ZONING CASE NUMBER: C814-2014-0120 – Austin Oaks PUD

ZONING CHANGE REVIEW SHEET

CASE: C814-2014-0120 – Austin Oaks Planned Unit Development

Exhibit C, Land Use Plan

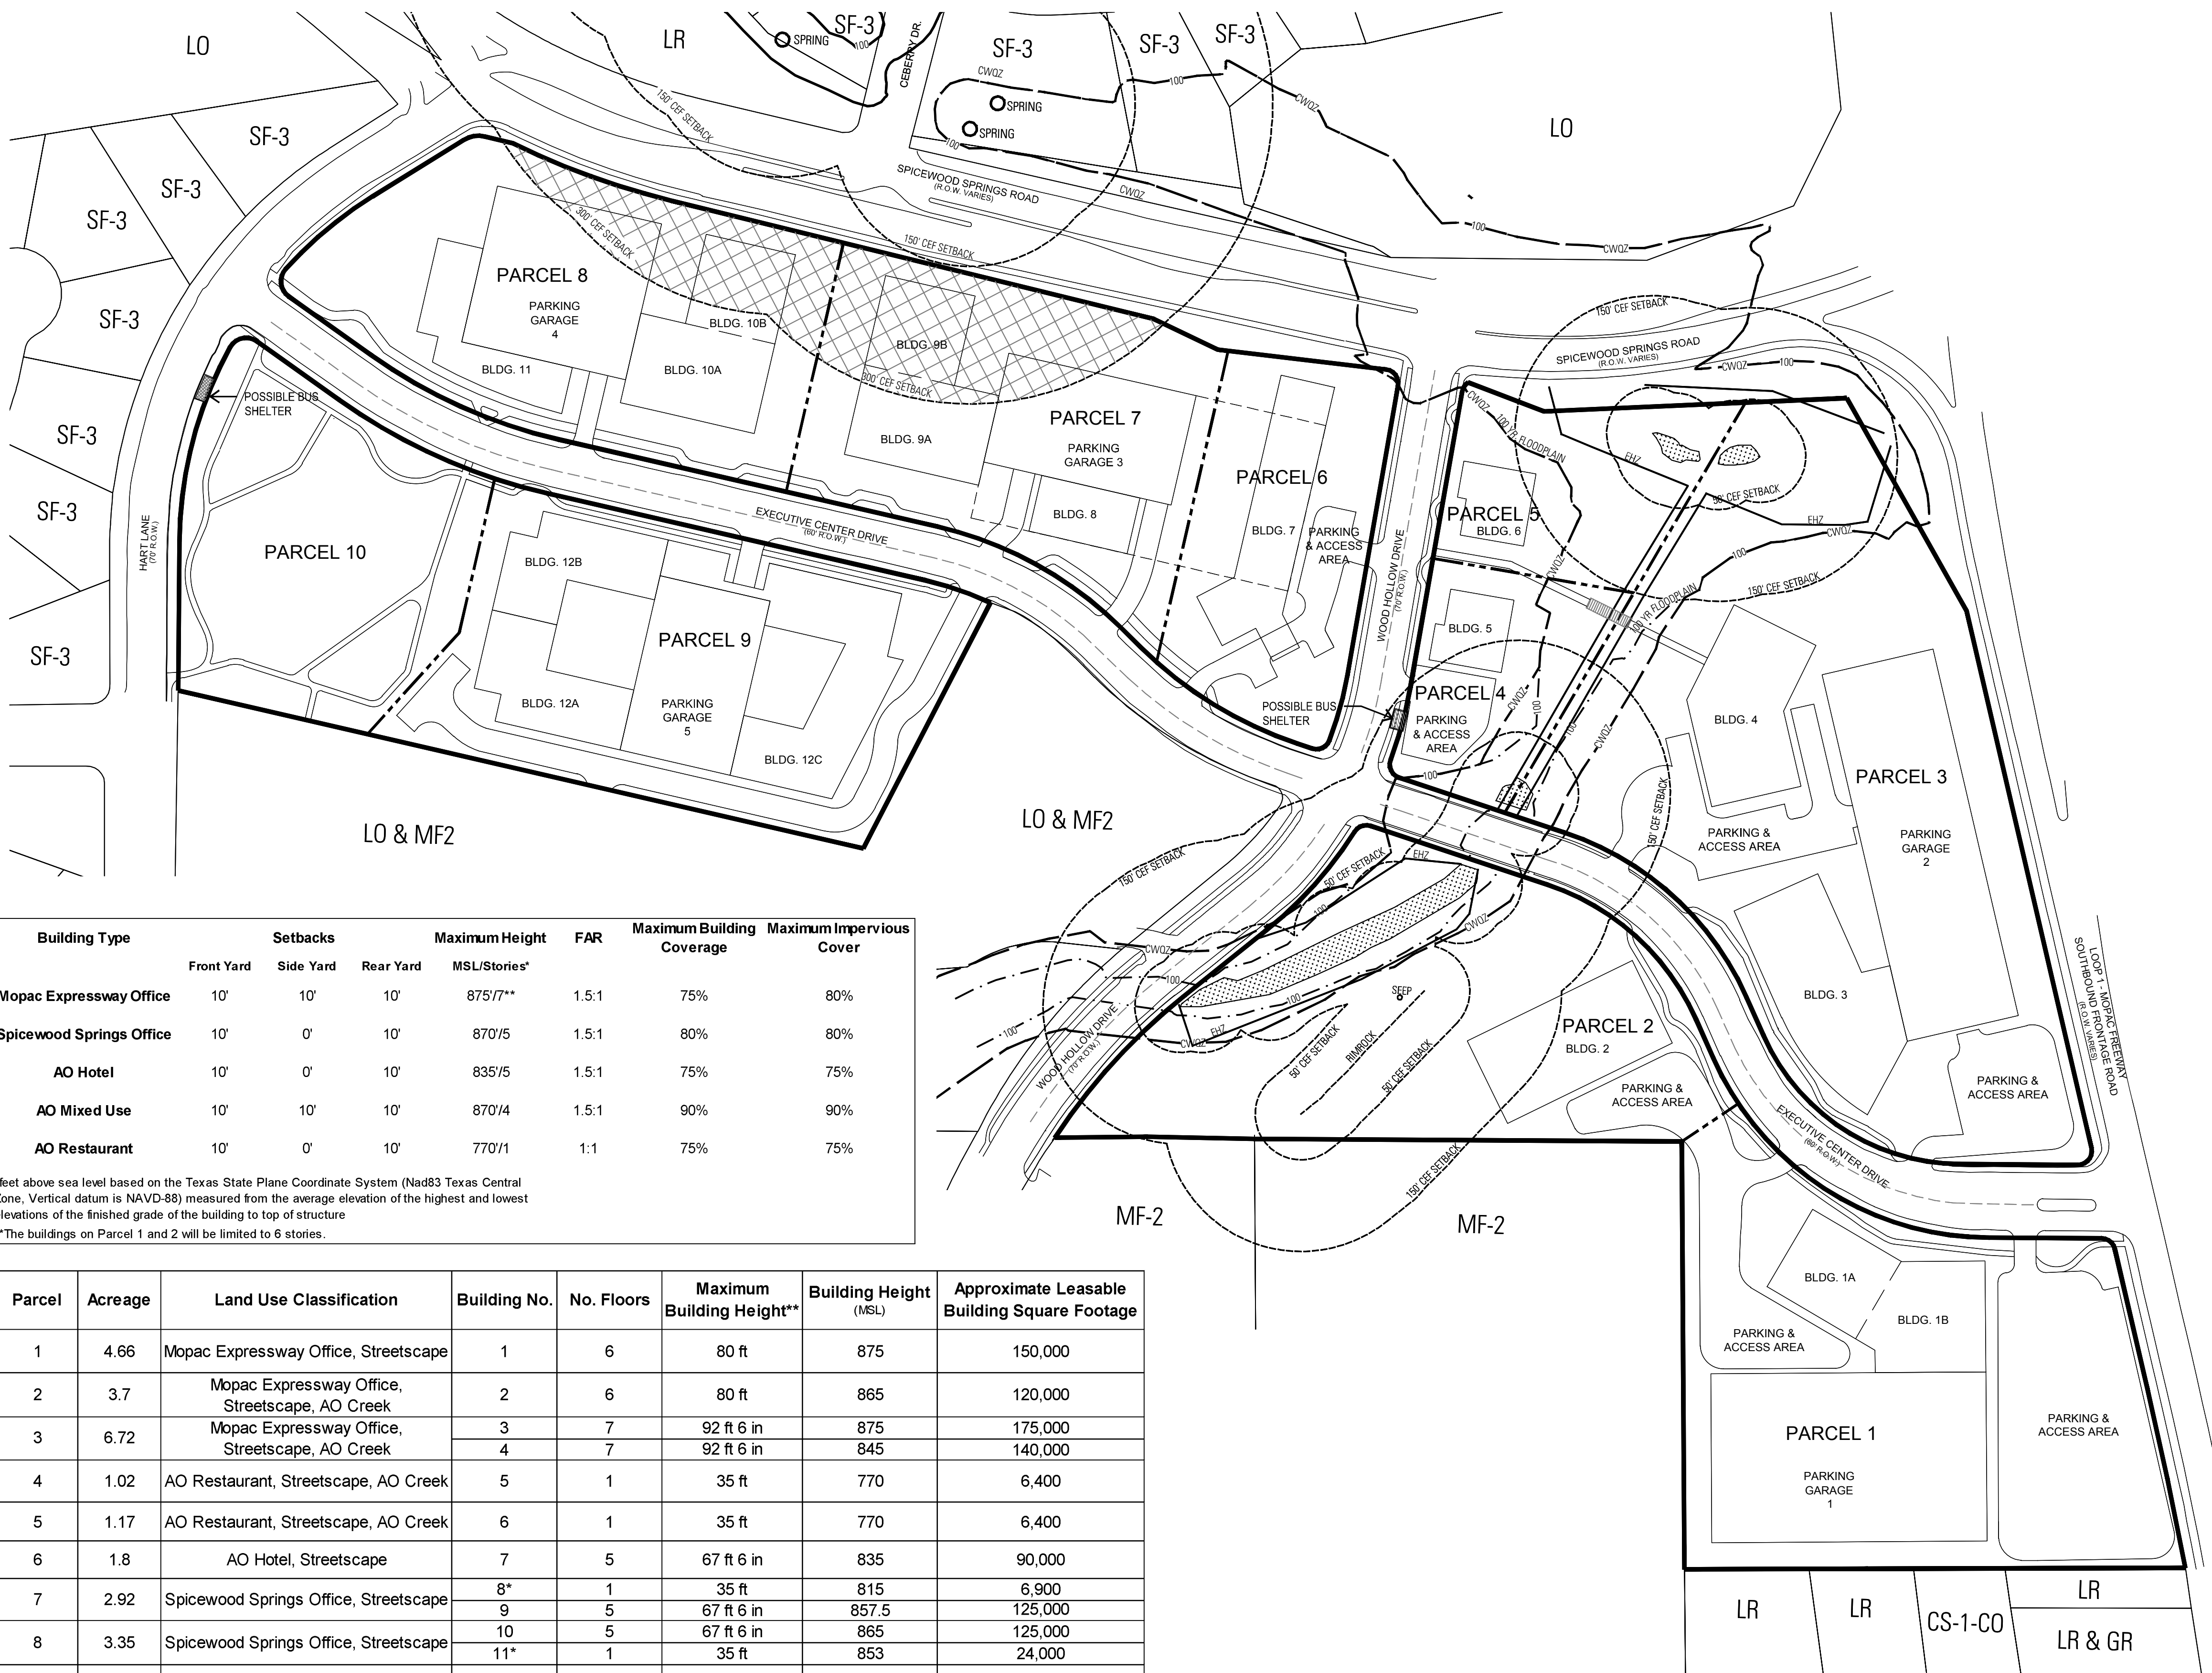
EO 15. The CWQZ, 100-year floodplain, and CEF buffers are difficult to read on this plan. Please revise the symbology to better illustrate the environmental features on the land use plan. Can the Erosion Hazard Zone and Drainage Easements be removed to make the plan easier to read?

Update 4: Under 25-8-92(F), the boundaries of a CWQZ in an urban watershed coincide with the boundaries of the 100-year fully developed floodplain, with a minimum width of 50' and a maximum width of 400'. There are several places where the 100-year fully developed floodplain extends beyond the identified CWQZ. Please correct the CWQZ boundaries to follow the 100-year fully developed floodplain in areas where the floodplain width is between 50' and 400' from the creek centerline. (Maintain a minimum CWQZ width of 50' where the floodplain is narrower than 50' from centerline.)

Update 5: Comment cleared.

EXHIBIT G
PAGE 1 OF 2
AUGUST 30, 2016
UDG JOB NO. 15-864
1"=100'
CASE NUMBER: C814-2014-0120

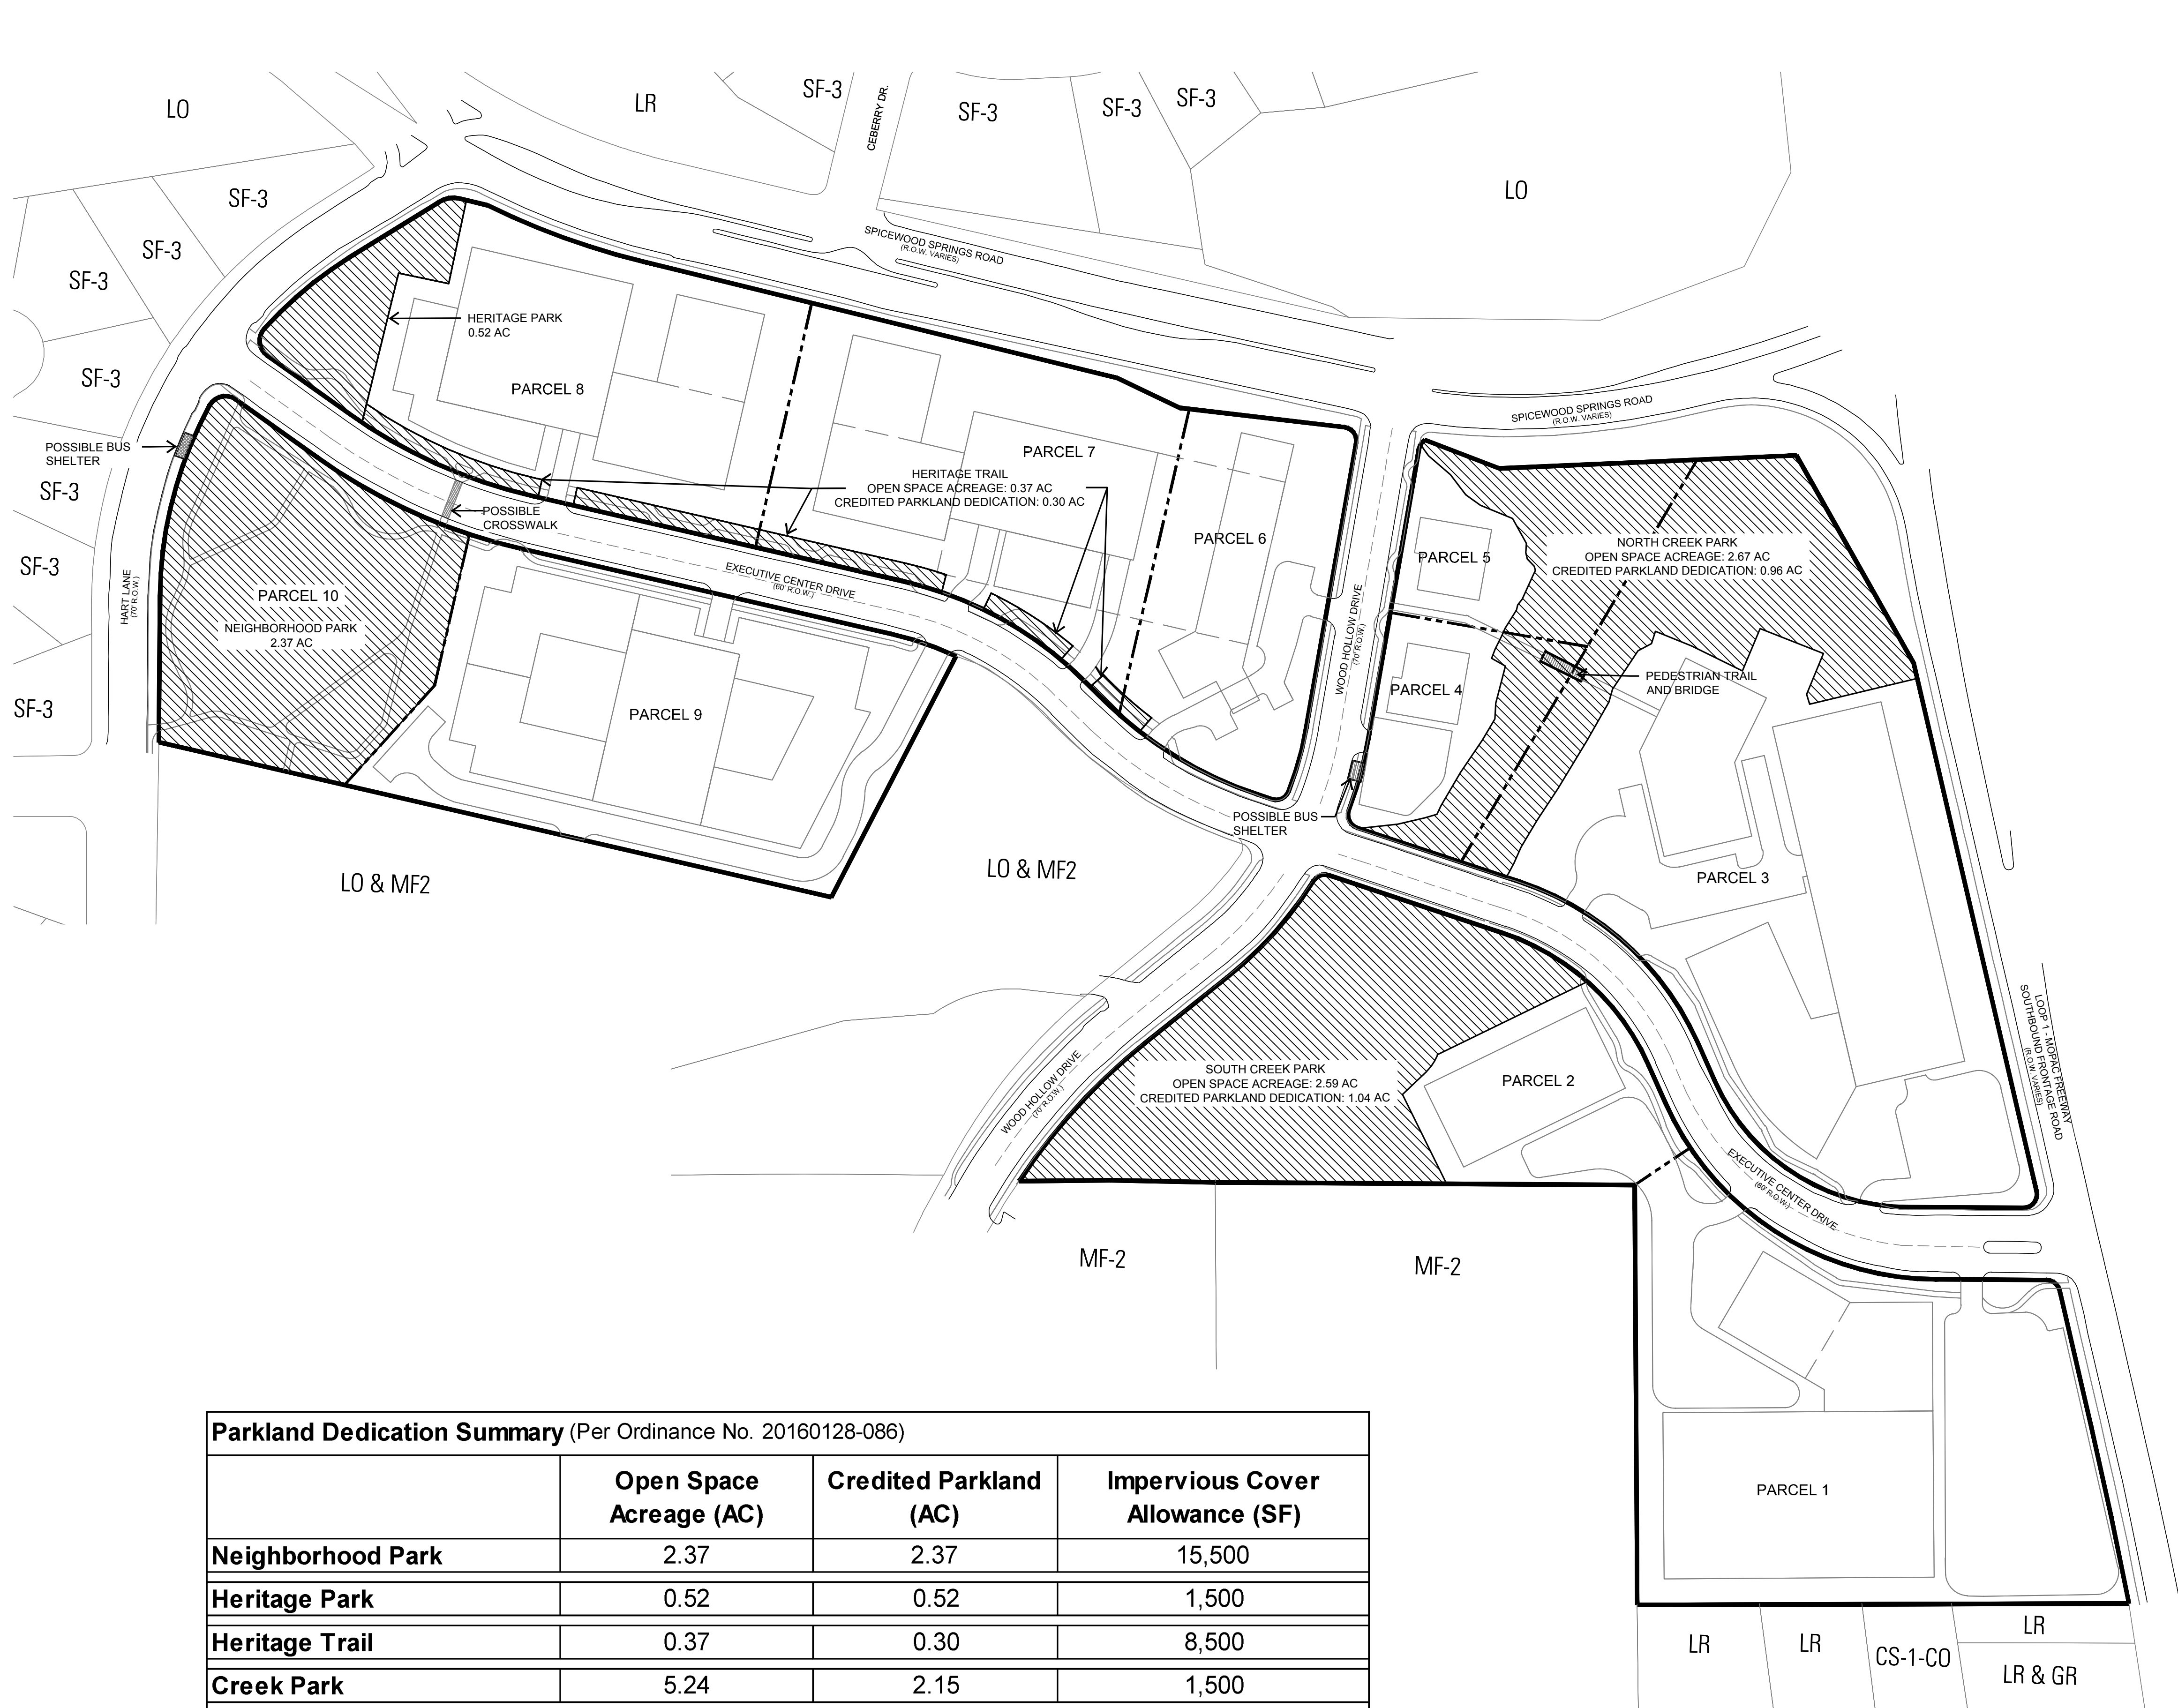
EO 34. The Parkland Dedication Summary table allocates 14,000 square feet of impervious cover for the Creek Park. Is this number intended to include the trail? If the trail is public it will not count towards the impervious cover limit; however, the square footage of noncompliant development does need to be calculated and incorporated into the PUD. Please clarify whether the 14,000 square feet includes the trail and if so, provide the estimated size of the trail. Any requested park development that would not comply with CWQZ or CEF buffer requirements should be subtracted from the proposed restoration area. See comment EO 7.

Update 5: Comment cleared.
